HARTING Product Change Notification

PCN/19/006/C+N

Title: Change PPv4 old to PPv4 redesign for copper cable assemblies -
External

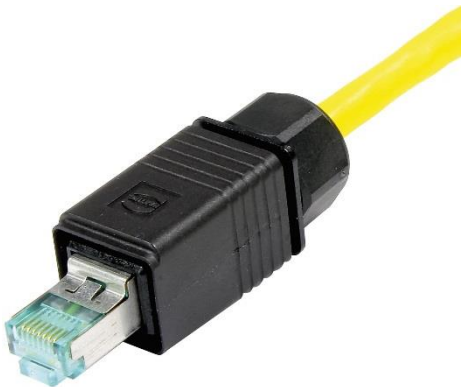
In September 2017 HARTING announced the Product Launch of the new designed HARTING PushPull V4 Industrial. Because both connector designs are 100% mating compatible it is a logical step to announce the change of the parts in our HARTING PushPull copper cable assemblies from the old design to the new designed HARTING PushPull V4 Industrial.

- 100% Mating compatible between old and new design
- During the period of change there might be a mesh of the old and new design at our stock.
